ORCHARD GARDENS REDEVELOPMENT
DEVELOPMENT FOR:
FIRST COMMUNITY HOUSING
245 W. WEDDELL DRIVE, SUNNYVALE, CA 94089

100% CONSTRUCTION DOCUMENTS & PERMIT SUBMITTAL
ISSUED ON:
07.14.2025

Misc. Plan Permit - Substantial Conformance Documentation

1 SITE PLAN - MISC. PLANNING PERMIT ADJUSTMENT DRAWING
1" = 20'-0"

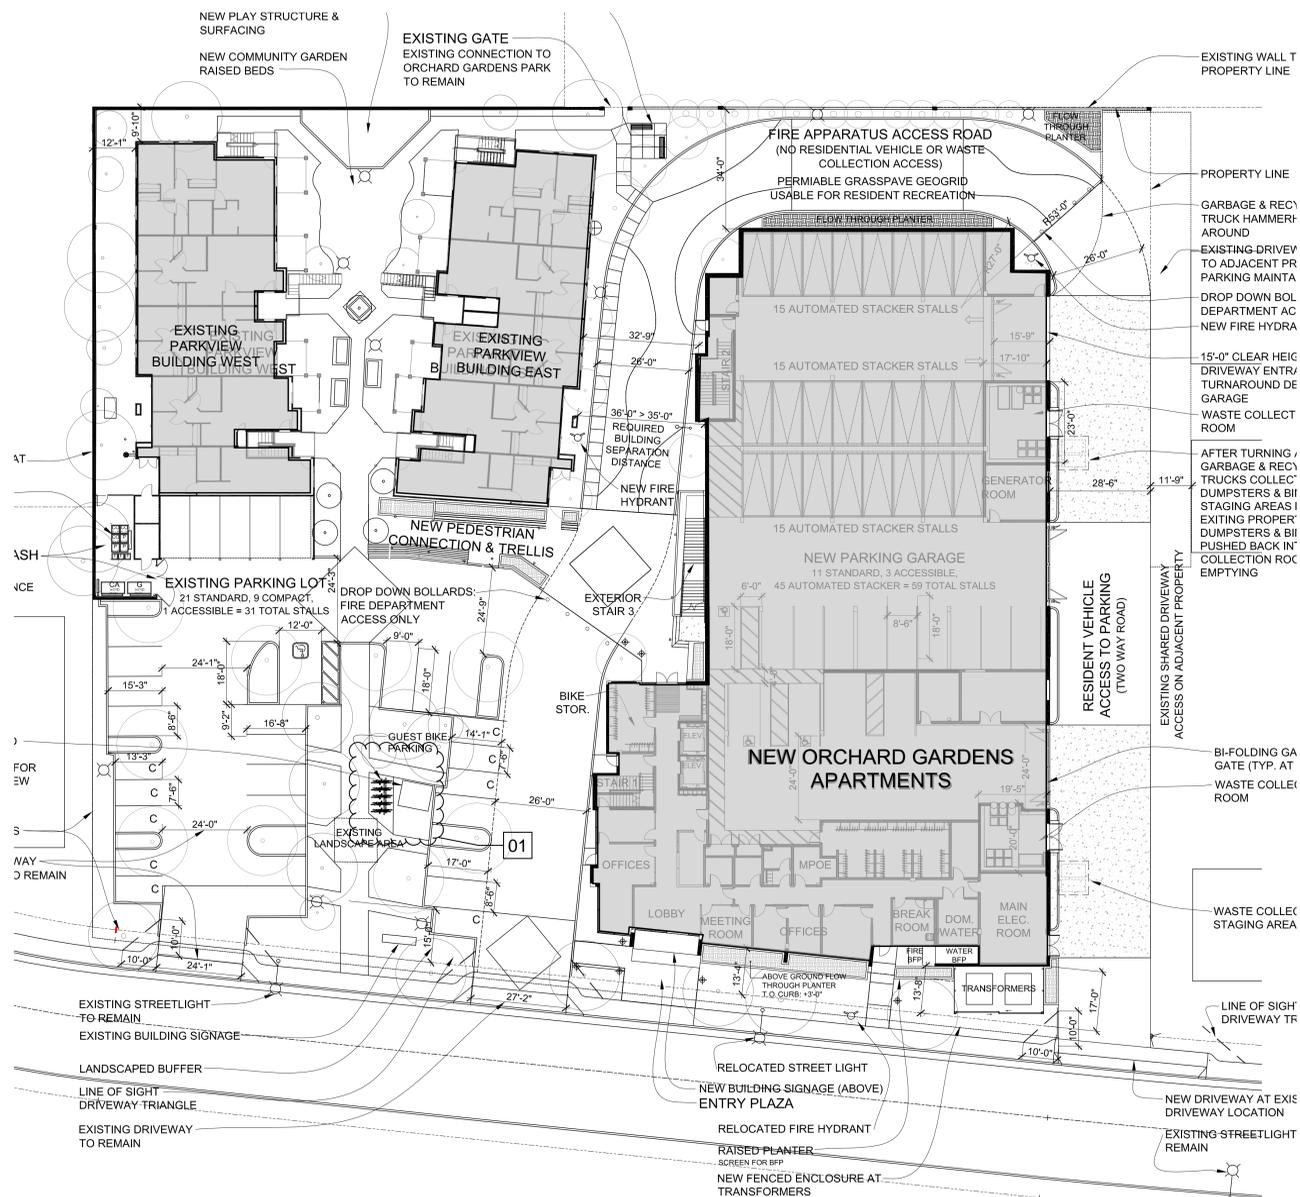
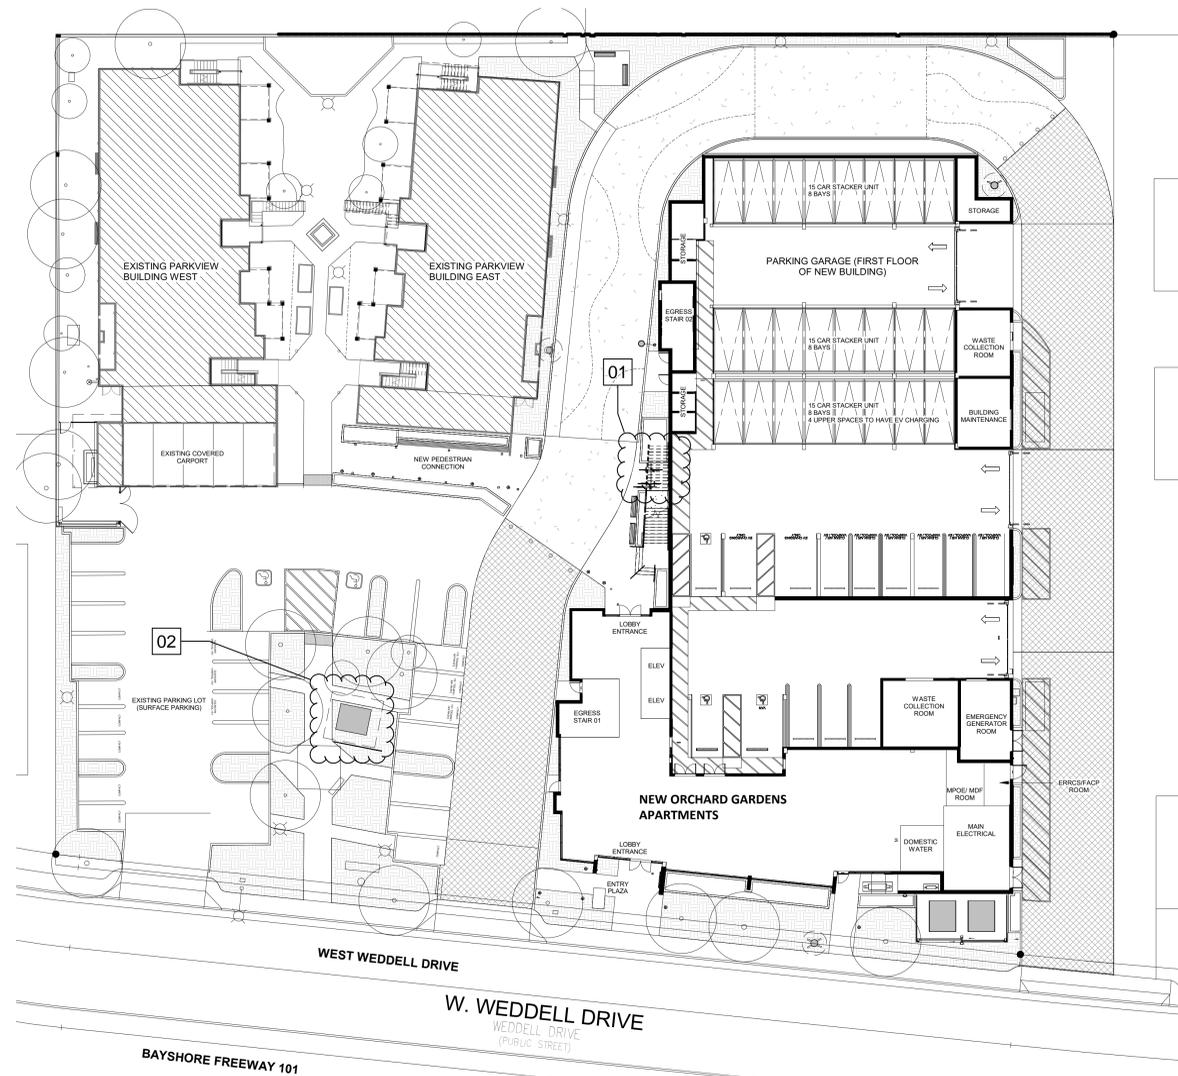
- 01 *GUEST BIKE PARKING
 - 02 *SCREEN WALL AT PARKVIEW TRANSFORMER
- *STARRED ITEMS WERE PART OF THE PREVIOUSLY REVIEWED MPP SET,
REVIEWED AUGUST 2022

1 SECOND FLOOR PLAN
SCALE: 1/16" = 1'-0"
MISC. PLANNING PERMIT ADJUSTMENT DRAWING

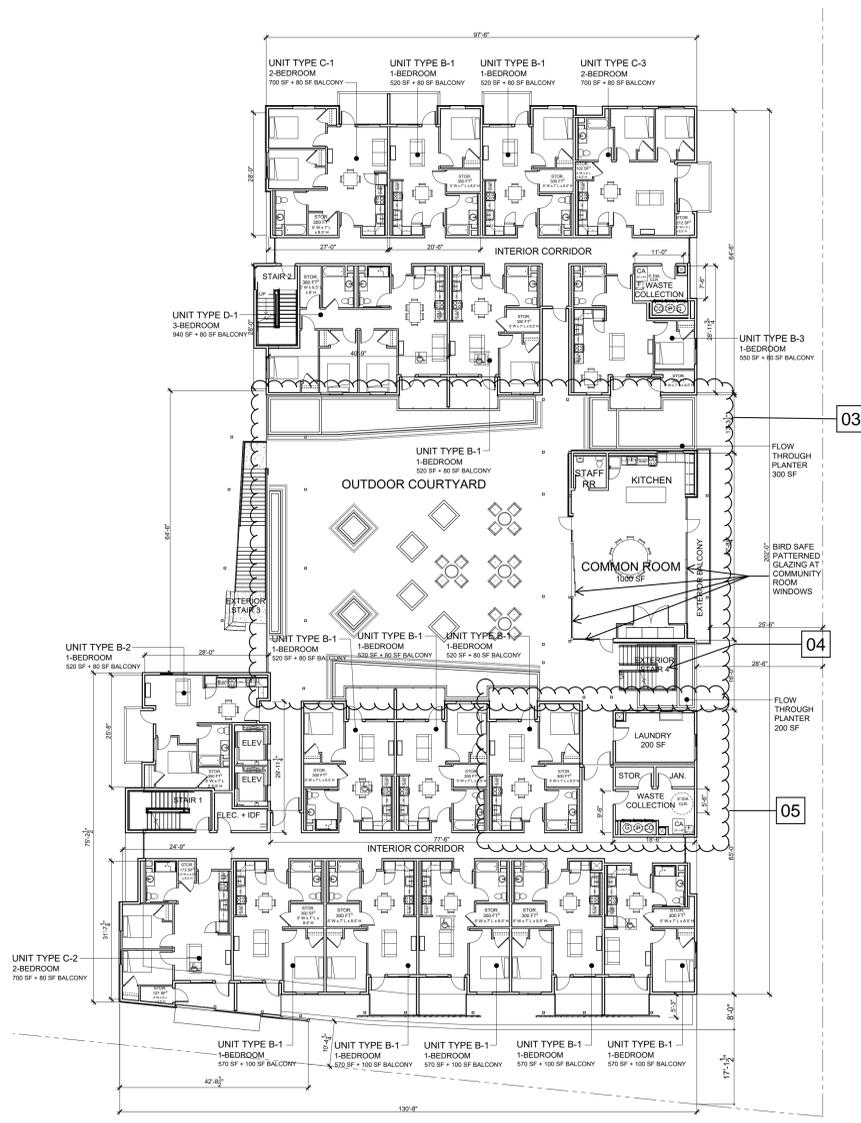
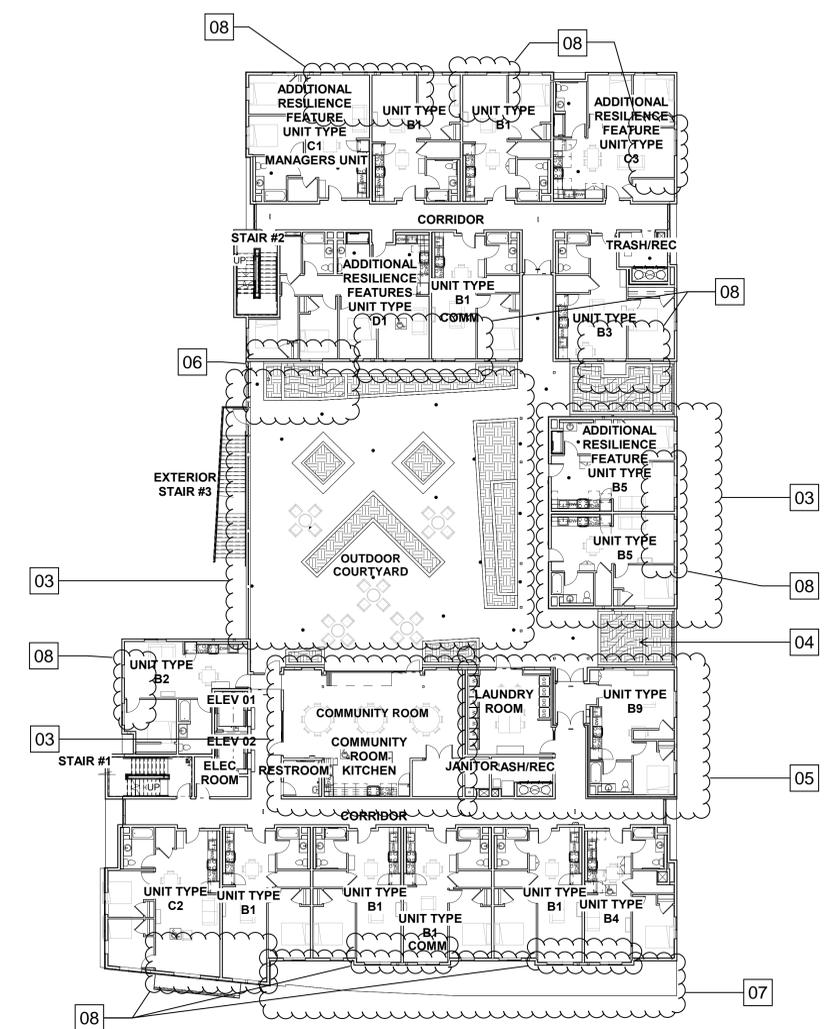
- 09 REMOVAL OF SOUTHERN SCREEN WALLS AND BALCONIES.
- 10 *ROOFTOP EQUIPMENT SCREEN REVISED TO SOLID WALL, NOT VISIBLE FROM STREET.
- 11 *HIGHEST SLOPED PORTION OF THE ROOF RAISED TO 75'-5" ALONG THE EAST SIDE OF BUILDING
- 12 REPLACE CENTRALIZED VRF SYSTEM WITH PTHP, PROVIDE NECESSARY LOUVERS
- 13 PLANTER WALL MATERIAL AT FRONT ELEVATION CHANGED FROM WOOD BOARD OVER CONCRETE TO CMU

1 SOUTH ELEVATION (STREET ELEVATION) - MISC. PLANNING PERMIT ADJUSTMENT DRAWING
1/8" = 1'-0"

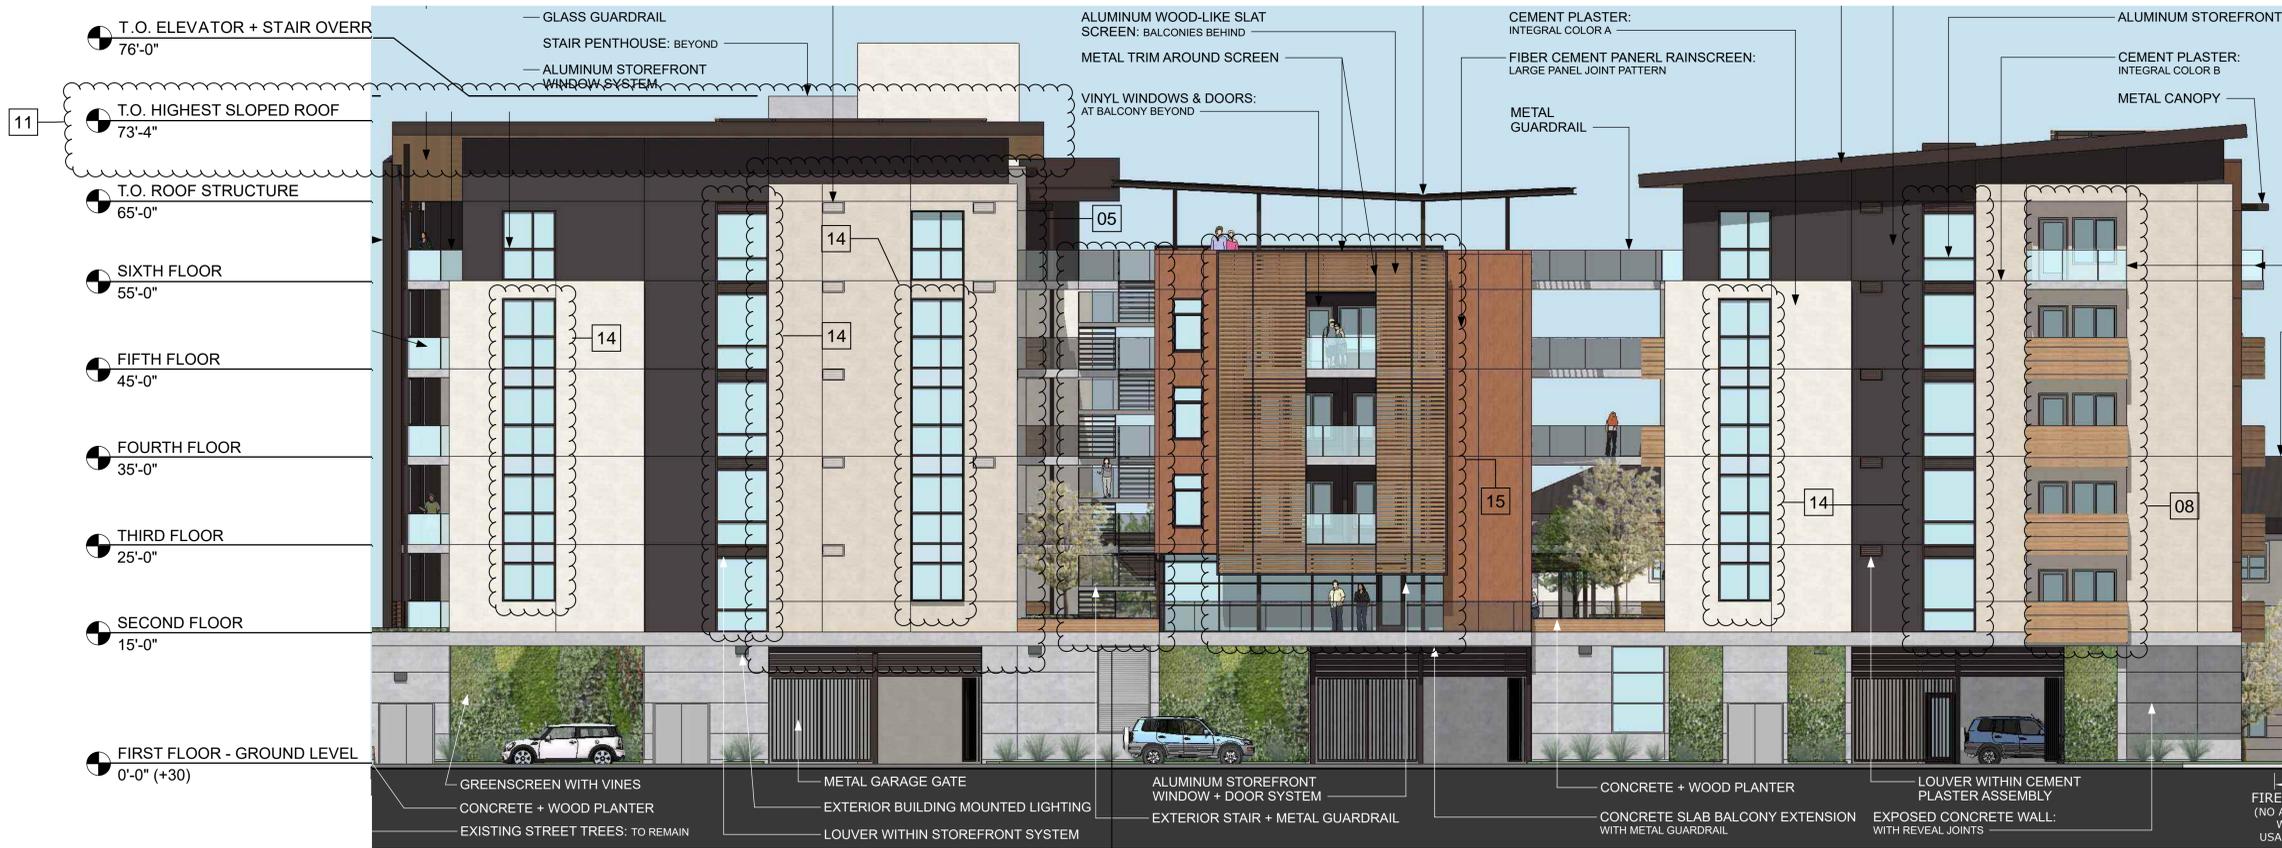
- 04 *EXTERIOR STAIR 04 REMOVED. ENLARGED RAISED PLANTERS IN PLACE.
 - 05 *BUILDING A COMMON ROOM AND RESIDENTIAL UNIT STACK SWAPPED
 - 08 REMOVED ALL BALCONIES.
 - 11 *HIGHEST SLOPED PORTION OF THE ROOF RAISED TO 75'-5" ALONG THE EAST SIDE OF BUILDING
 - 12 REPLACE CENTRALIZED VRF SYSTEM WITH PTHP, PROVIDE NECESSARY LOUVERS
 - 14 REPLACE STOREFRONT AND WINDOW WALL WITH PUNCHED OPENINGS
 - 15 BUILDING B1 EXTERIOR FACADE UPDATED TO REFLECT COMMON ROOM RELOCATION.
- *STARRED ITEMS WERE PART OF THE PREVIOUSLY REVIEWED MPP SET, REVIEWED AUGUST 2022

1 EAST ELEVATION - MISC. PLANNING PERMIT ADJUSTMENT DRAWING
1/8" = 1'-0"

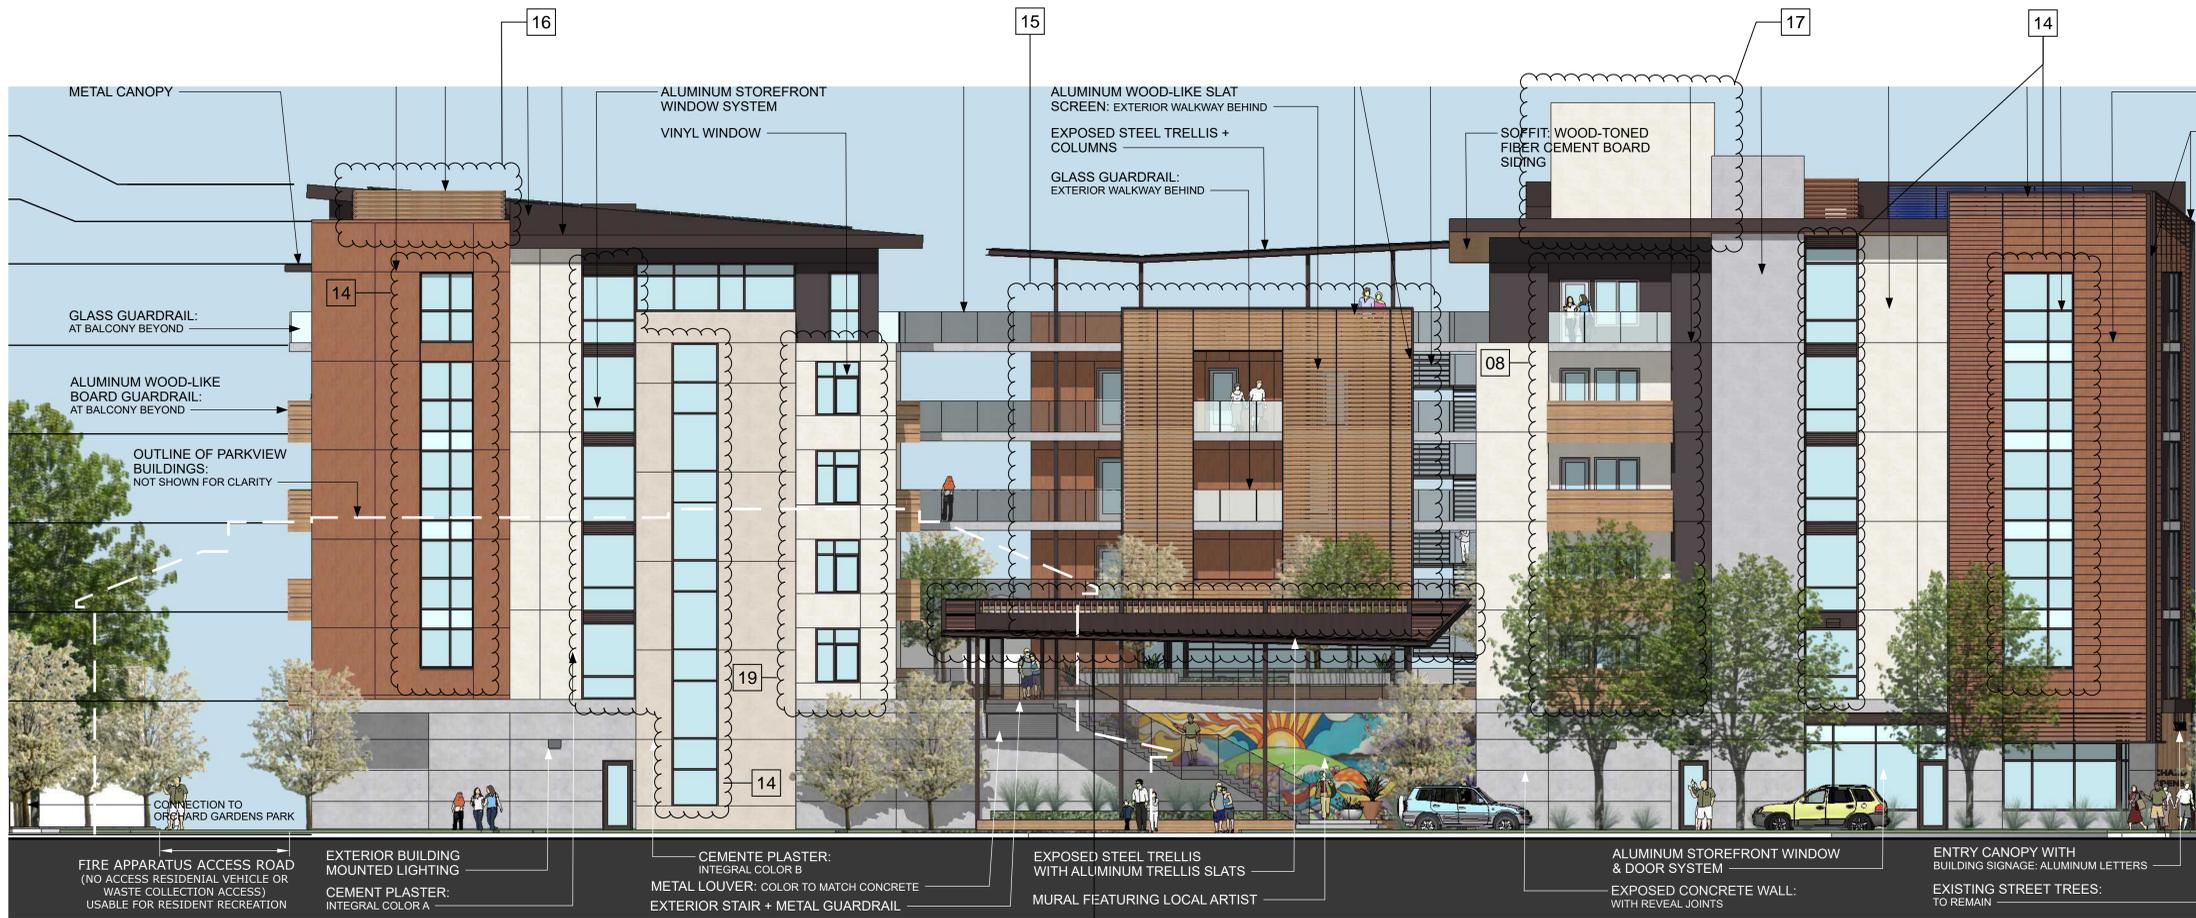
- 08 REMOVED ALL BALCONIES.
 - 12 REPLACE CENTRALIZED VRF SYSTEM WITH PTHP, PROVIDE NECESSARY LOUVERS
 - 14 REPLACE STOREFRONT AND WINDOW WALL WITH PUNCHED OPENINGS
 - 15 *BUILDING B1 EXTERIOR FACADE UPDATED TO REFLECT COMMON ROOM RELOCATION.
 - 16 REMOVED VRF EQUIPMENT AND ROOF EQUIPMENT SCREEN ON BUILDING B2.
 - 17 ELEVATOR OVERRUN HEIGHT REDUCED TO 73'-6"
 - 18 REMOVAL OF STEEL CANOPY OVER EXTERIOR STAIR
 - 19 WINDOW LITES AND MULLIONS SHIFTED TO MAINTAIN OSHA GUARDRAIL REQUIREMENTS
 - 20 VERTICAL METAL PICKET GUARDRAIL
- *STARRED ITEMS WERE PART OF THE PREVIOUSLY REVIEWED MPP SET, REVIEWED AUGUST 2022

1 NORTH ELEVATION - BUILDING A
1/8" = 1'-0"
MISC. PLANNING PERMIT ADJUSTMENT DRAWING

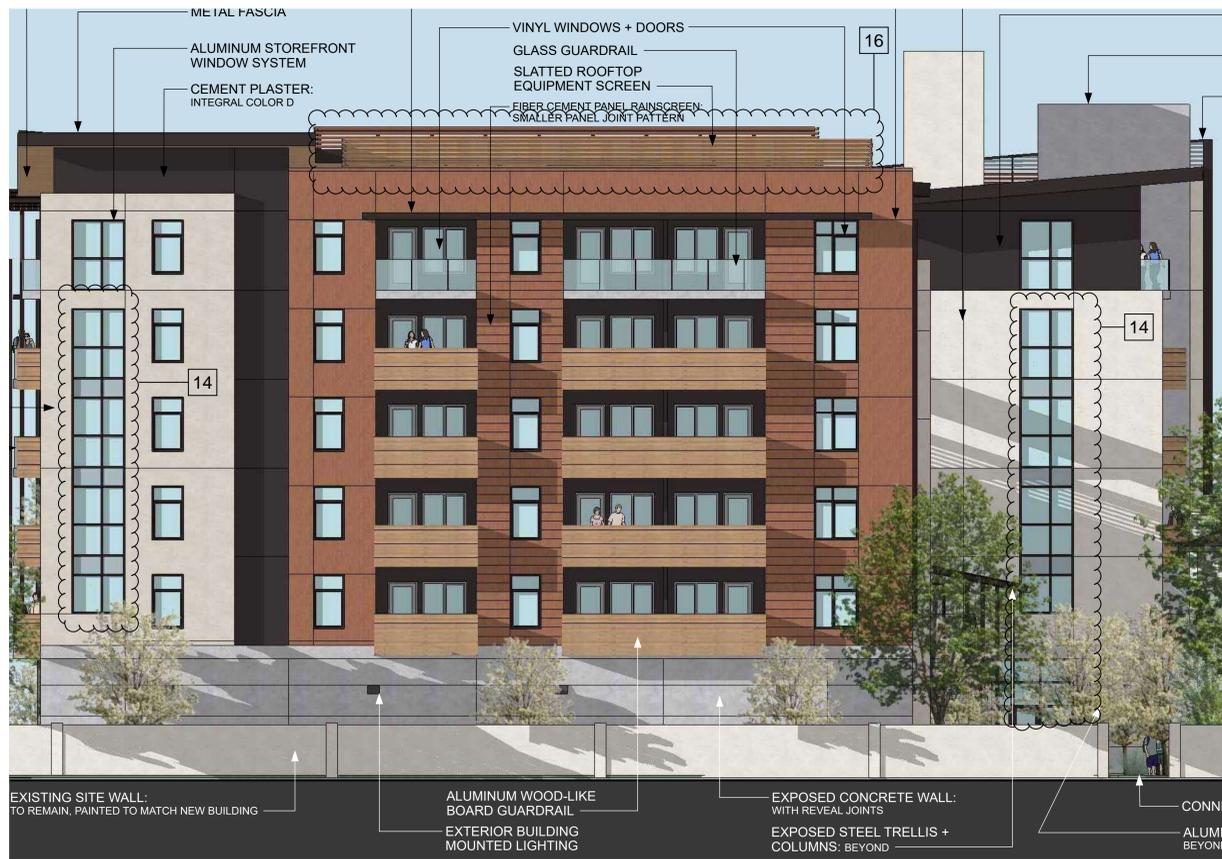
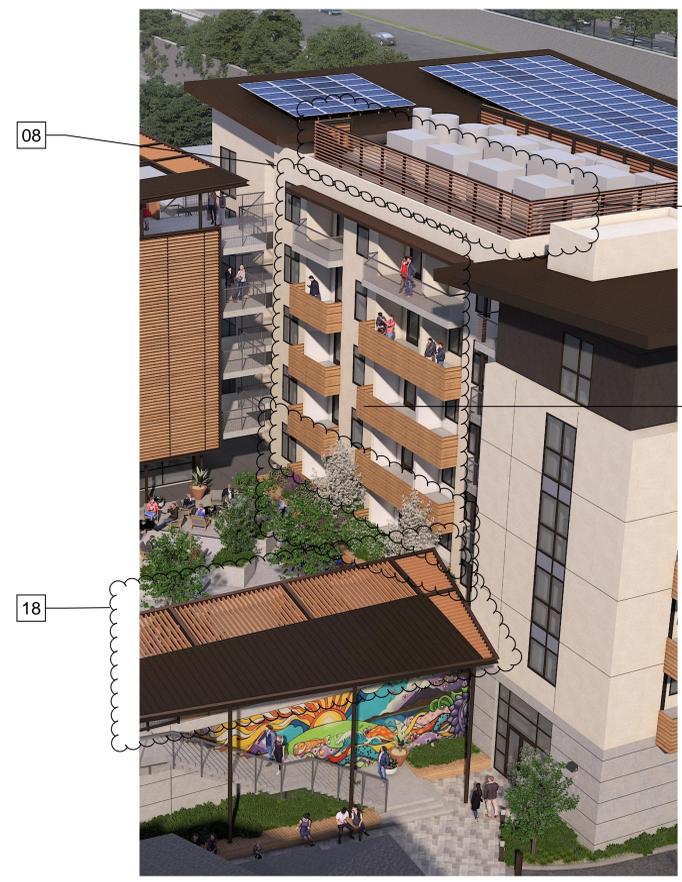
- SHEET NOTES**
- 03 *COMMUNITY ROOM RELOCATION AND COURTYARD ROTATION
 - 08 REMOVED ALL BALCONIES.
 - 12 REPLACE CENTRALIZED VRF SYSTEM WITH PTHP, PROVIDE NECESSARY LOUVERS
 - 14 REPLACE STOREFRONT AND WINDOW WALL WITH PUNCHED OPENINGS
 - 16 REMOVED VRF EQUIPMENT AND ROOF EQUIPMENT SCREEN ON BUILDING B2.
 - 18 REMOVAL OF STEEL CANOPY OVER EXTERIOR STAIR
 - 21 ROOFTOP EQUIPMENT REDUCED DUE TO CHANGE FROM VRF TO PTHPS
- *STARRED ITEMS WERE PART OF THE PREVIOUSLY REVIEWED MPP SET, REVIEWED AUGUST 2022
